ANSTY GARDEN COMMUNITY,

DESIGNERS RESPONSE

REPORT REF NO. 2207280-R14B

- 1.6 The following drawing have been prepared to incorporate the findings of the RSA:
- **ACE Drawing 2207280-004F** – Proposed Roundabout Western Access (A272)

At Scale: 1:500	Date: 22.02.23	Designed by: DV
Drawn by: DV	Checked by: DV	Approved by: DH
Drawing Number: 2207280-004		Rev: F

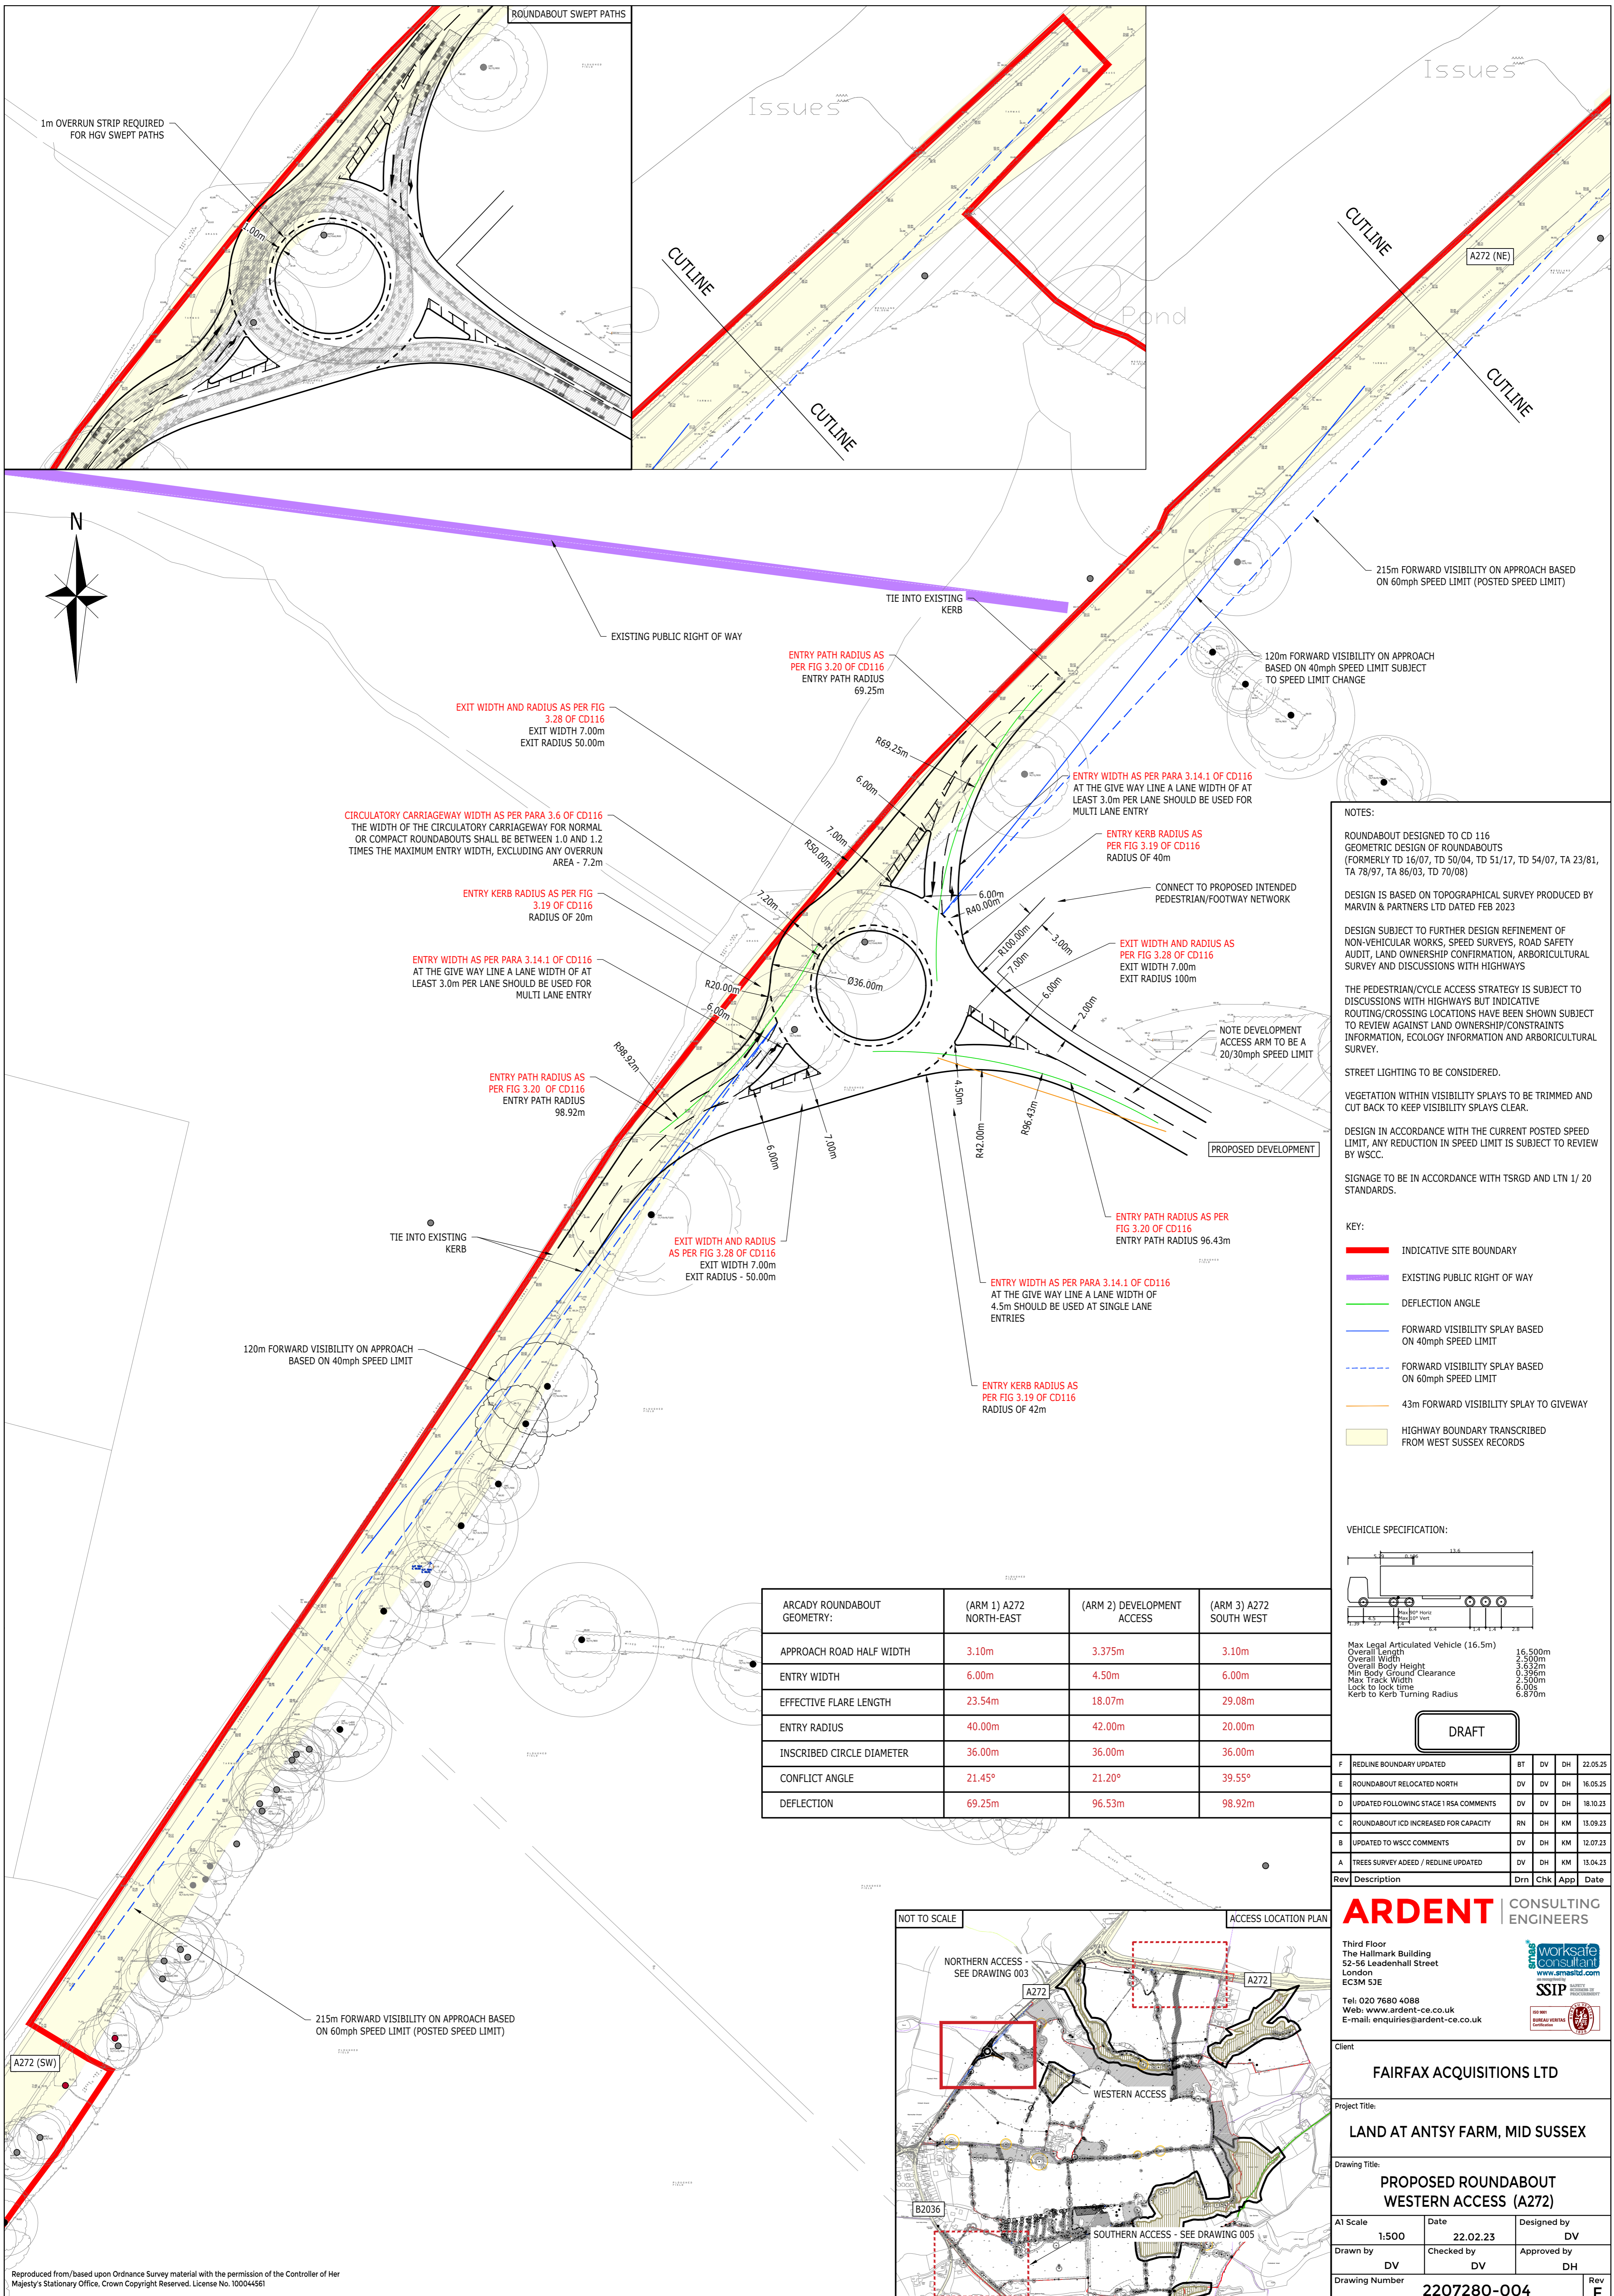
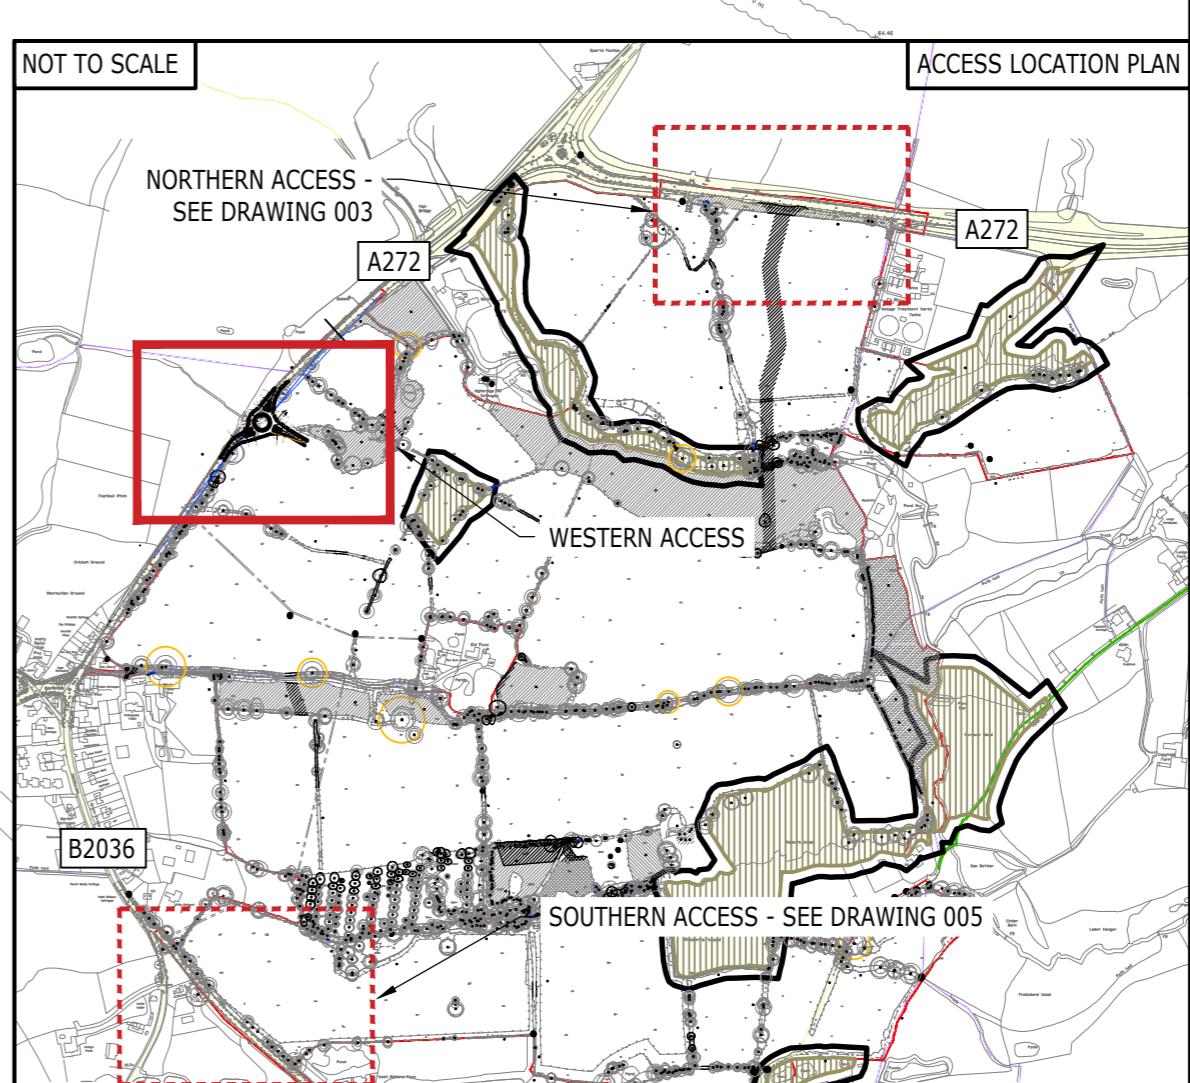
<p>3.2.2 Insufficient Stopping Sight Distance may increase the risk of junction related or shunt type collisions at the roundabout.</p> <p>On the southwest bound approach to the roundabout SSDs have been provided for assessment. However, there is concern that the SSDs pass over non-highway land. Vegetation or landscaping features in these splays could restrict visibility, where insufficient visibility may increase the risk of junction related or shunt type collisions at the roundabout.</p>	<p>It is recommended that a suitable covenant should be arranged to ensure that the splay is not affected by planting or landscaping features.</p>	<p>Agree. All visibility splays are within highway land or land within the development site and therefore can be kept clear as shown and noted on ACE Drawing 2207280-004F.</p>	<p>All visibility splays to be provided in highway land or within land under the applicants control.</p>	<p>No further action at this stage.</p>

<p>3.2.3 Insufficient Stopping Sight Distance may increase the risk of junction related or shunt type collisions at the roundabout.</p> <p>On the approach to the roundabout no SSD has been provided for assessment. There is concern that the SSD could pass over non-highway land. Vegetation or landscaping features in this splay could restrict visibility, where insufficient visibility may increase the risk of junction related or shunt type collisions at the roundabout.</p>	<p>It is recommended that the SSD should be supplied for assessment and that they should be within the adoptable highway, or that a suitable covenant should be arranged to ensure that the splay is not affected by planting or landscaping features.</p>	<p>Agree. The development arm of the roundabout will be subject to a 20/30mph speed limit. All visibility splays are within highway land or land within the development site and therefore can be kept clear as shown and noted on ACE Drawing 2207280-004F.</p>	<p>Visibility splays in keeping with a 30mph speed limit are shown on the plan and are acceptable.</p>	<p>No further action at this stage.</p>

<p>3.2.4 Lack of vertical profile information could lead to side impact collisions or loss of control collisions.</p> <p>The proposed roundabout is located on the A272, where there is a fall from the southwest to the northeast. At this early stage no vertical alignment details were provided for assessment. There is concern that inappropriate vertical profiles could restrict visibility at the junction, which may lead to side impact collisions or loss of control collisions.</p>	<p>It is recommended that vertical alignment details should be provided for assessment at Stage 2 Safety Audit.</p>	<p>Agree. Details of vertical alignments will be provided for Stage 2 Audit.</p>	<p>Vertical alignments to be provided at detailed design.</p>	<p>Vertical alignments to be provided at detailed design.</p>
<p>3.2.5 The exit layouts from the roundabout increase the risk of side swipe collisions, rear end shunts or loss of control collisions.</p> <p>On all arms, the proposed exits from the roundabout are two lanes wide, narrowing to one lane over a short merge length. The layout encourages aggressive drivers to overtake a slower moving vehicle over a relatively short distance. There is concern that such overtaking manoeuvres could lead to side swipe collisions, rear end shunts or loss of</p>	<p>It is recommended that the exits from the roundabout should be restricted to one wide lane.</p>	<p>Agree. The exits have been reduced and two marked lanes are no longer proposed. The comment is accepted and drawing updated as set out on ACE Drawing 2207280-004F.</p> <p>The exit widths are in accordance with CD116 Para 3.28.2 <i>'At a normal roundabout, if the downstream link is a single carriageway road, the exit width should be between 7 metres and 7.5 metres and the exit should taper down to a minimum of 6 metres. NOTE The</i></p>	<p>The two lane exit has now been removed and hatching provided to reduce the width of the running lane. Vehicle tracking is also provided and shows HGVs would not over run the hatching.</p>	<p>No further action at this stage.</p>

<p>control collisions, particularly as one of the of the merges is on a bend.</p>		<p><i>additional width allows traffic to pass a broken down vehicle.'</i></p> <p>The amended design accords with DMRB requirements as shown on ACE Drawing 2207280-004F.</p>		
<p>3.3.1 Insufficient capacity could lead to rear end shunt or side impact collisions.</p> <p>No details of expected flows and the capacity of the roundabout have been provided for assessment. Insufficient capacity could lead to congestion where excessive queuing at the roundabout could lead to driver frustration and the use of inappropriate gaps, further unbalanced flows could lead to entry problems on to the roundabout. This may lead to rear end shunt or side impact collisions.</p>	<p>It is recommended that the roundabout should operate without excessive queuing and with balanced flows and that an ARCADY or similar model should be provided for assessment.</p>	<p>Agree. An ARCADY assessment has been undertaken and demonstrates that the junction operates with spare capacity in the Development Case scenario. The results are attached at Appendix C.</p>	<p>Junction Modelling has been provided and indicates the junction would work within capacity in a 2039 future year scenario.</p>	<p>No further action at this stage.</p>

<p>3.3.2 Low angle of entry may increase the risk of side impact collisions.</p> <p>The angle of entry was provided for assessment, where for northeastern and development arms the angle of entry was less than twenty degrees. Low angles of entry could force drivers to look over their shoulders or use their mirrors to merge with circulating traffic, increasing the risk of side impact collisions.</p>	<p>It is recommended that the angle of entry should lie between 20o and 60o.</p>	<p>Agree. Conflict angles have been re-calculated in accordance with CD116 Para 3.18.1. The geometry table has been updated as shown on ACE Drawing 2207280-004F.</p>	<p>Conflict angles are shown between 21.2o and 39.55o</p>	<p>No further action at this stage.</p>
<p>3.5.1 Insufficient street lighting could lead to loss of control collisions and side impact collisions during the hours of darkness.</p> <p>At this early stage no details of street lighting have been provided for assessment. A lack of lighting could increase the risk of loss of control and side impact collisions at the roundabout during the hours of darkness.</p>	<p>It is recommended that street lighting should be checked with the Highway Authority’s street lighting team and that a plan showing the light distribution should be provided for assessment at Stage 2 Safety Audit.</p>	<p>Agree. It has been noted on ACE Drawing 2207280-004F that street lighting is to be considered in liaison with WSCC as per the recommendation. Lighting details to be provided for Stage 2 Audit.</p>	<p>Street lighting details to be provided at detailed design.</p>	<p>Street lighting details to be provided at detailed design.</p>
